**ABBOTT
ADD**

INDEX INSTRUMENT SERVICE ADVISORY

COMMANDER® FPC(TM) (76)

SUBJECT: Troubleshooting Guide for FPC (TM) Pipettor Tip Dropping	ISA#: 76-045A
ORIGINATOR: John Buckland	PRODUCT: COMMANDER® FPC(TM) (76)
APPROVED: Dan Armstrong 03-SEP-1999	EFFECTIVITY DATE: 03-SEP-1999

**** Part # 1-73446-01**

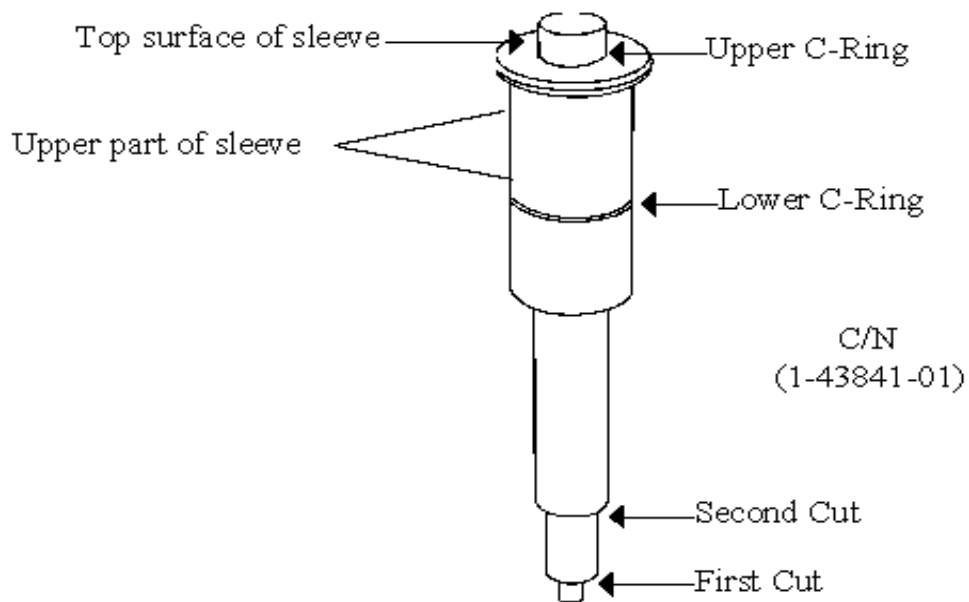
1. To Correct wrong Part # on Alignment Gauge drawing in ISA 76-045 from 1-73466-01 to 1-73446-01. The changes in this ISA will have an ** by it.
2. To assist field support personnel with the identifying and resolving causes for FPC Pipettors dropping a pipette tip during an assay run. The release of changes to the

C. Alignment Gauge, Part # 1-73446-01 (U-shaped tool which fits into the notch of Tip Nozzle Assembly).

**** Part # 1-73446-01**

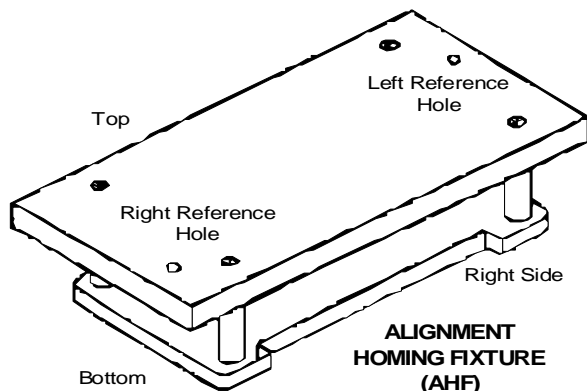
1. To Correct wrong Part # on Alignment Gauge drawing in ISA 76-044 from 1-73466-01 to 1-73446-01. The changes in this ISA will have an ** by it.
